UNITED STATES PATENT AND TRADEMARK OFFICE

| APPLICATION NO. | FILING DATE | FIRST NAMED INVENTOR | ATTORNEY DOCKET NO. | CONFIRMATION NO. |
|--|-------------|---------------------------|---------------------------|------------------|
| 10/533,205 | 03/20/2006 | David James Sealy Powling | KCX-983-PCT-US (17753) | 9103 |

Office Action Summary

DETAILED ACTION

Moore Marked-Up Figure 7

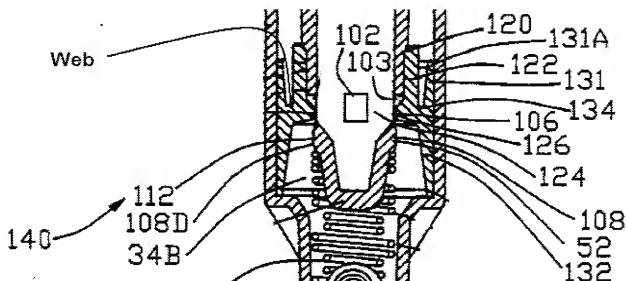
Regarding claim 6, Moore discloses the inner and outer walls to be connected by a radially extending web (see marked-up figure 7).
